Model: Booklet Finisher SR3160/SR3170	Date: 12-Nov-13	No.: RD688002b
---------------------------------------	-----------------	----------------

Subject: Staple misalignment (3 mm or more) occurs		Prepared by: Yuji Urushihara	
From: 1st Tech Service Sect. MFP/P Tech Service Dept.			
Classification:	<input checked="" type="checkbox"/> Troubleshooting	<input type="checkbox"/> Part information	<input type="checkbox"/> Action required
	<input type="checkbox"/> Mechanical	<input type="checkbox"/> Electrical	<input type="checkbox"/> Service manual revision
	<input type="checkbox"/> Paper path	<input type="checkbox"/> Transmit/receive	<input type="checkbox"/> Retrofit information
	<input type="checkbox"/> Product Safety	<input type="checkbox"/> Other ()	<input type="checkbox"/> Tier 2

Model: Booklet Finisher SR3160/SR3170

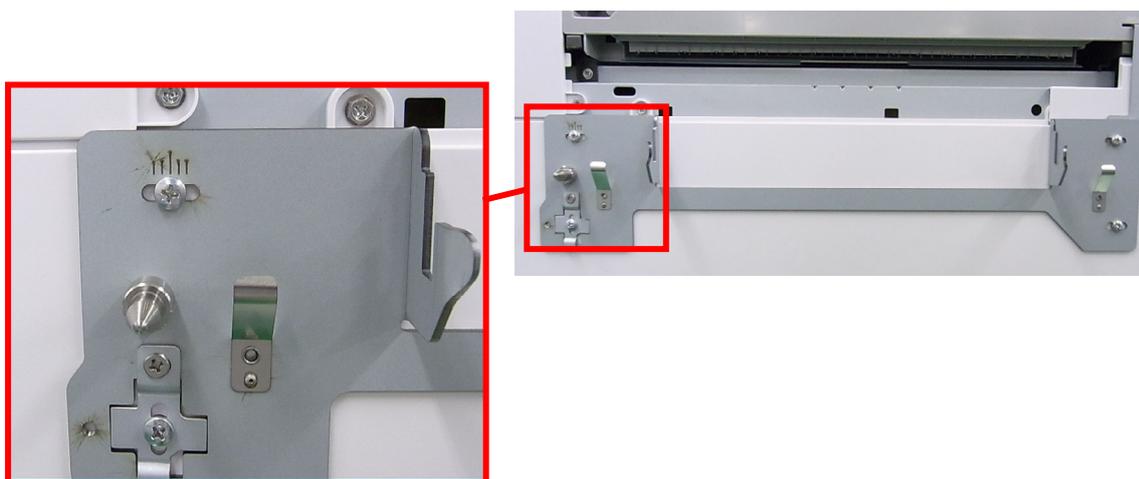
The shape of the bracket was changed and applied from the following cut-in S/N:

Attach the modified docking bracket to make it possible to adjust side-to-side registration at the joint between mainframe and finisher in accordance with the procedure below.

P/N:D6887610: for the docking bracket [A]

1. Secure the docking bracket [A] in its default attachment position (screws x 4).

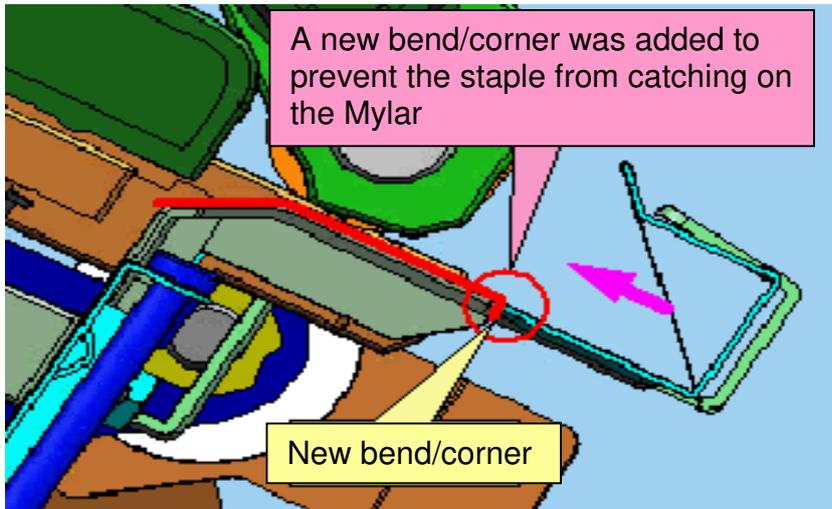
The staple of a stapled set catches on the guide Mylar attached to the jogger fence when the paper is output to the tray.

The shape of the Mylar was changed and applied from the following cut-in S/N:

Replace the Mylar with the modified one

D6884198: GUIDE:STAPLER:REAR

D6884199: GUIDE:STAPLER:FRONT

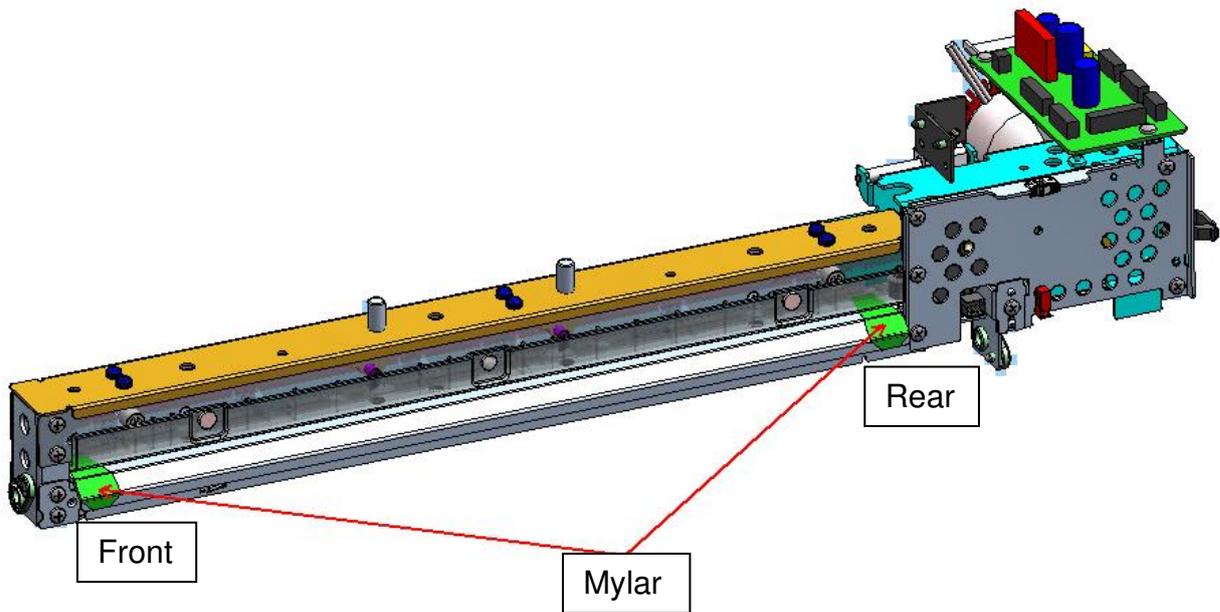
The paper may catch on the Mylar along the paper path inside the punch unit.

The Mylar has been deleted.

- Remove the punch unit from the machine
- Remove the two Mylars inside the punch unit (two different locations)

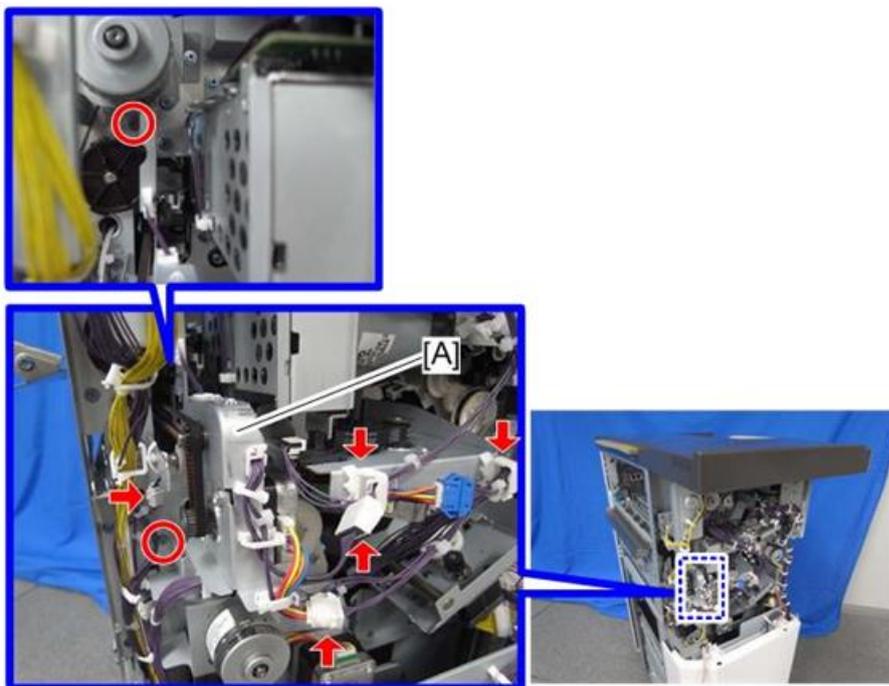
The paper contacts the Mylar on the punch unit (circled in red below).

This Mylar has been deleted.

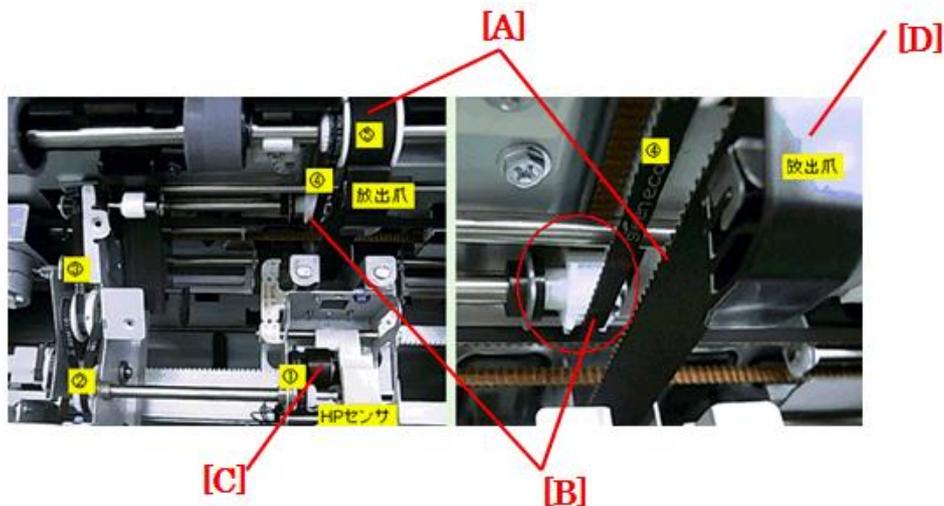
A previous jam or other force places a load on the exit pawls [A], causing the timing belt [B] to slip along the gear teeth. As a result, the home position [C] of the exit pawl is shifted and the pawl blocks part of the paper path [D].

1. Make sure the exit pawl is at its HP (home position).
Note: The pawl moves to its HP after the finisher initialization is performed.
2. Measure the distance between the exit bracket [A] and rear tip of the exit pawl [B] using a scale/ruler [C].
 - If this distance [D] is **NOT 51.2±2mm**, continue this procedure from Step 3 to adjust the position of the pawl manually.

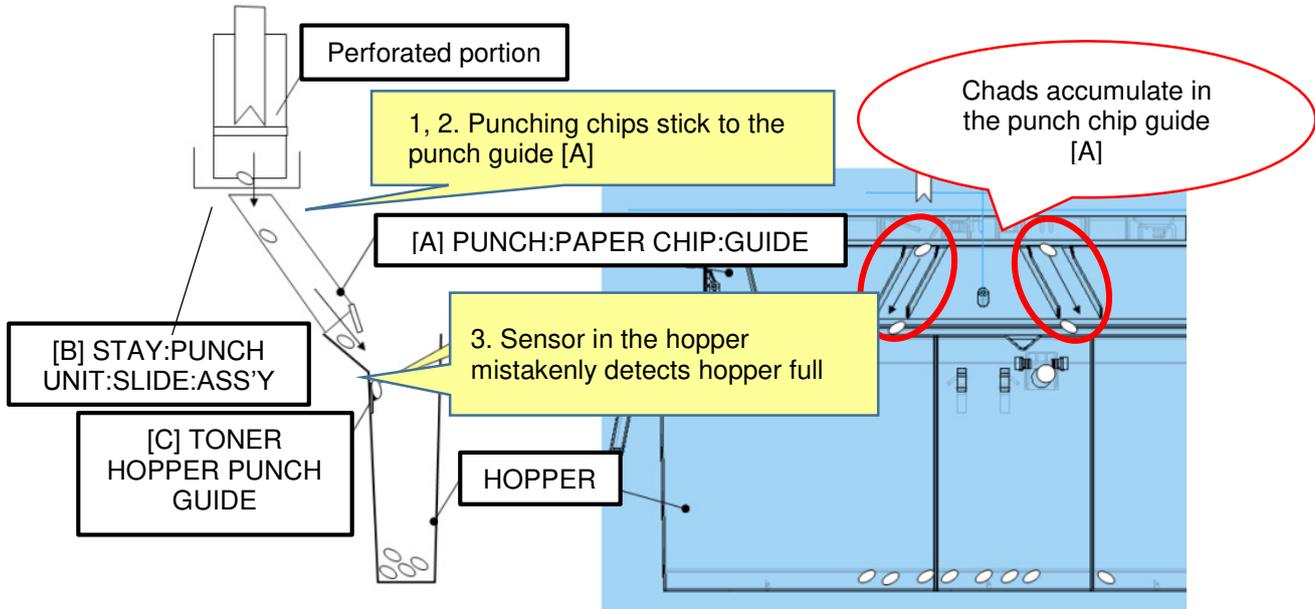
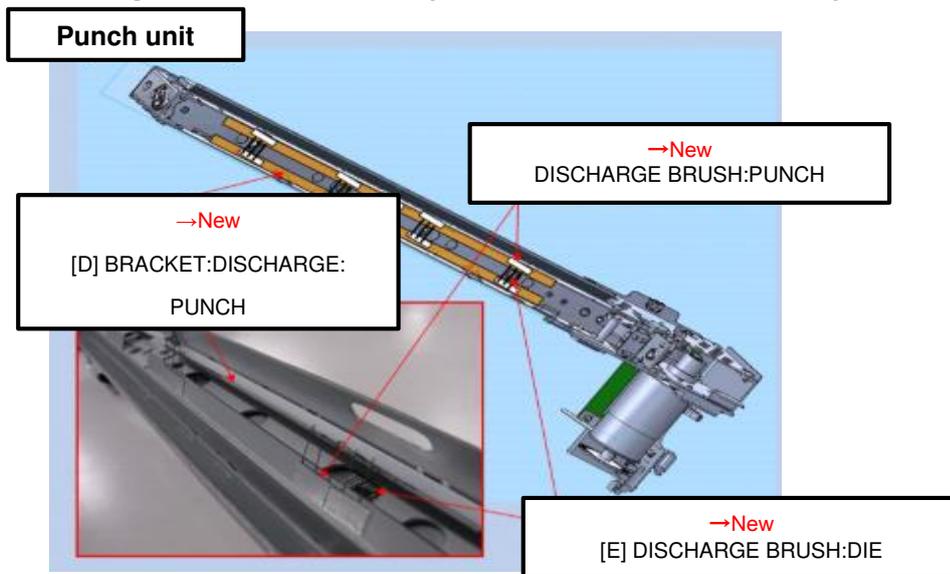
The chads stick to the punch guide [A] and then overflow into the transport path.

The chads stick to the toner hopper punch guide [C], causing the sensor to mistakenly detect the hopper full condition.

The punch unit, the punch unit stay, and the hopper were modified.

- Punch unit
A bracket [D] was added with a discharge brush [E] to the stay of the punch unit to discharge the static electricity from the chads immediately after holes are punched.

The stay of the punch unit

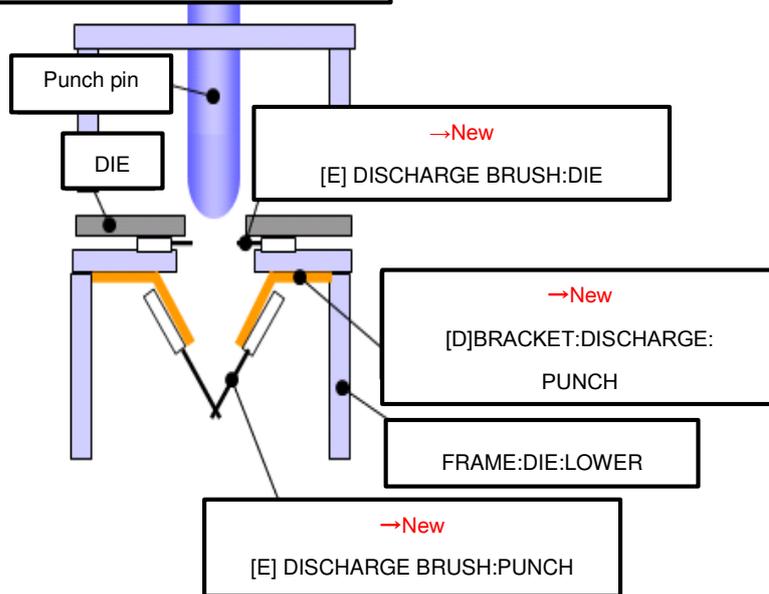
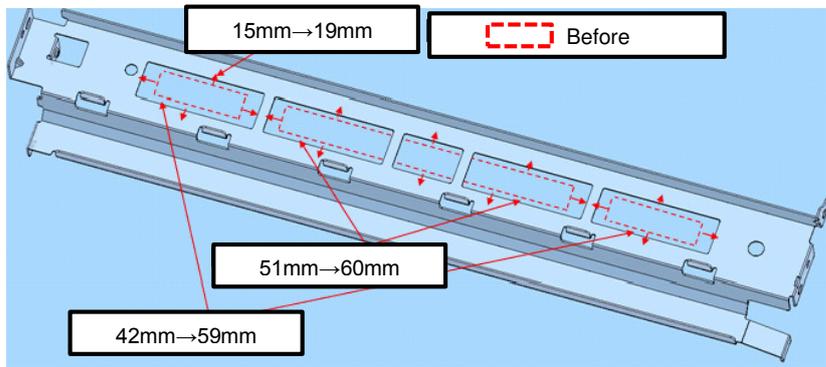
- **Punch unit stay**
The shape of the stay was changed to prevent chads from sticking to the stay.

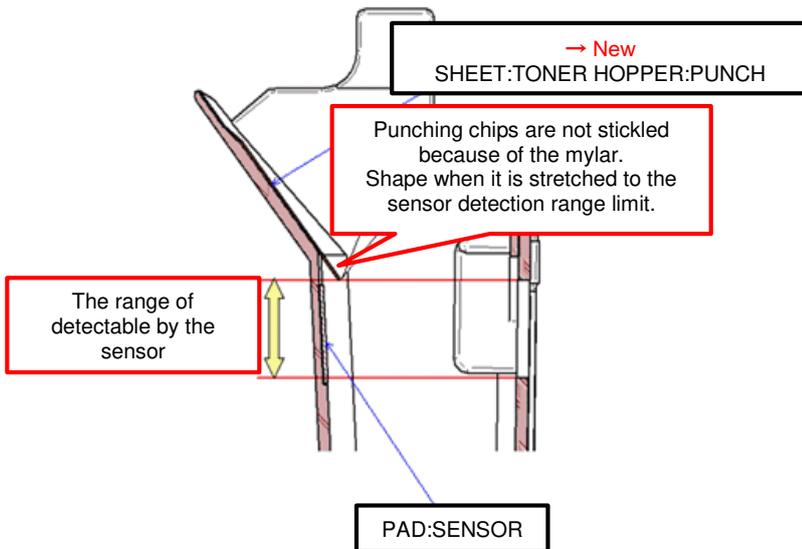
- **Hopper**
A Mylar was added to prevent chads from sticking to the sensor.

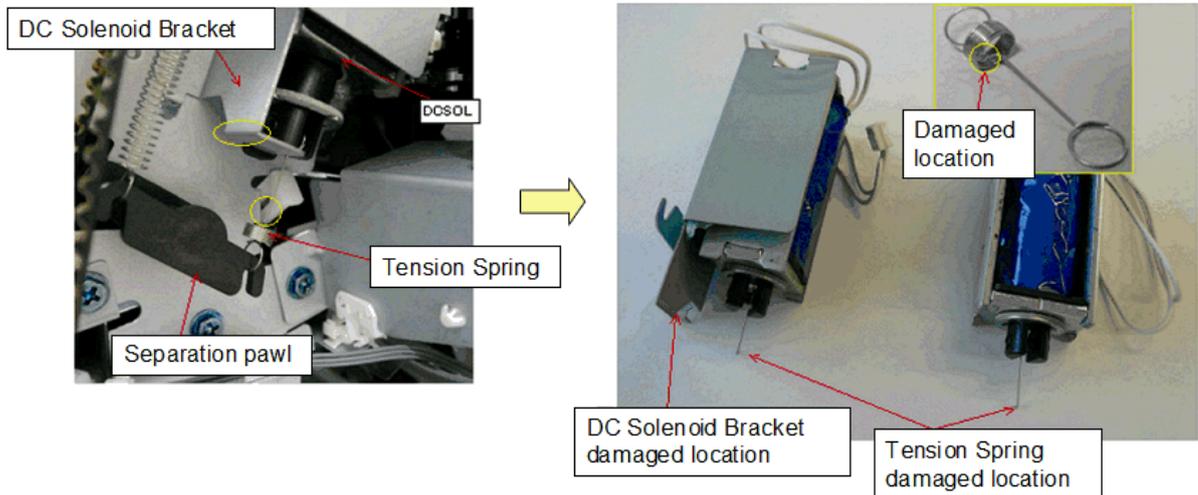
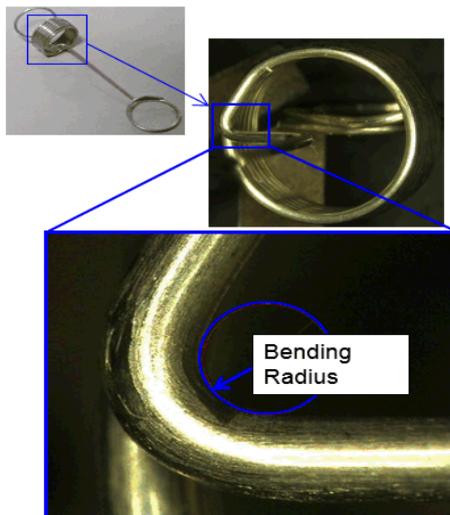
- 1. The spring and bracket for the gate solenoid break.

The small bend radius causes stress to concentrate on the spring.

The solenoid was modified.

Replace the solenoid (P/N D6882115)

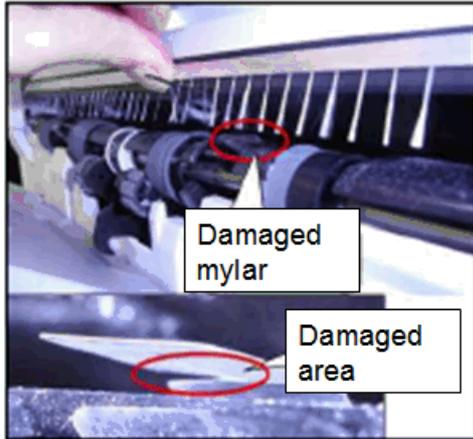
2. The Mylar is worn down by contact with the paper and eventually breaks.

The Mylar is gradually worn down by sliding friction produced by contact with the transported paper. This friction and the resulting stress are concentrated along the edge of the bending part of the Mylar.

The Mylar was modified.

Replace the Mylar (P/N D6884119)

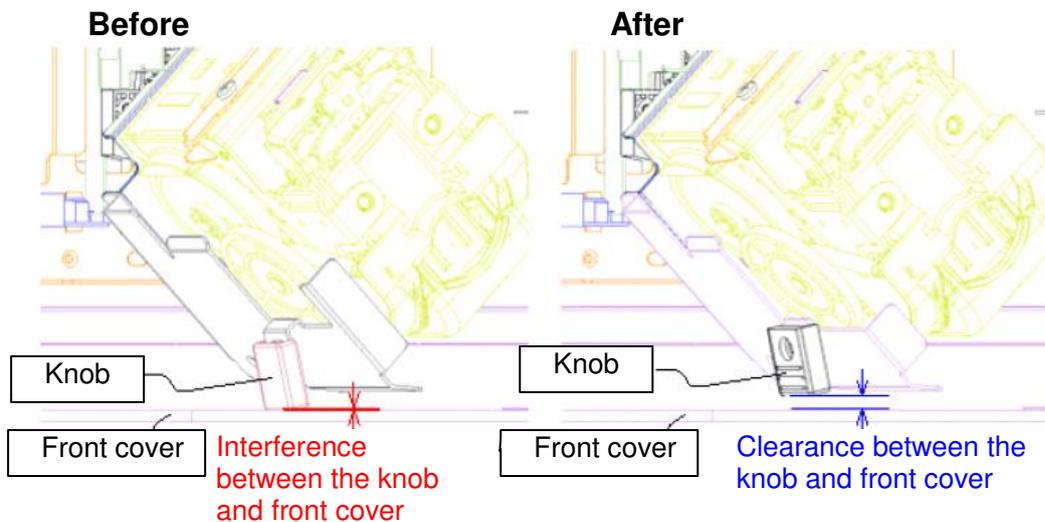
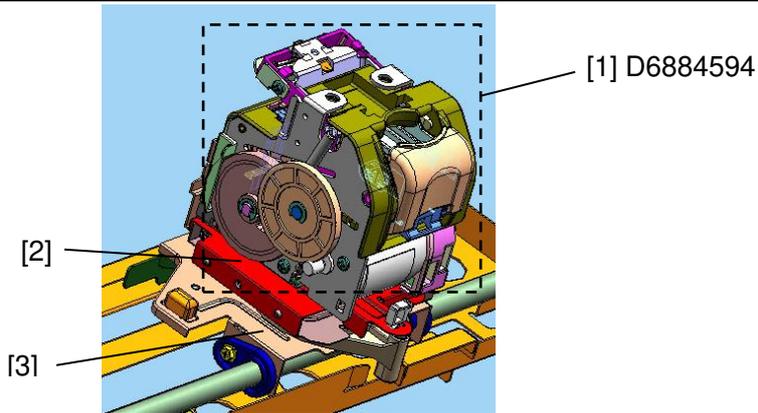
1. Knob on the stapler cover (snap-to-fit → screw)

2. Stapler brackets

1. Countermeasure against SC720 [2K/3K sheet finisher error]
The stapler bracket contacts the front cover and deforms, resulting in the above SC.
2. For improved production process
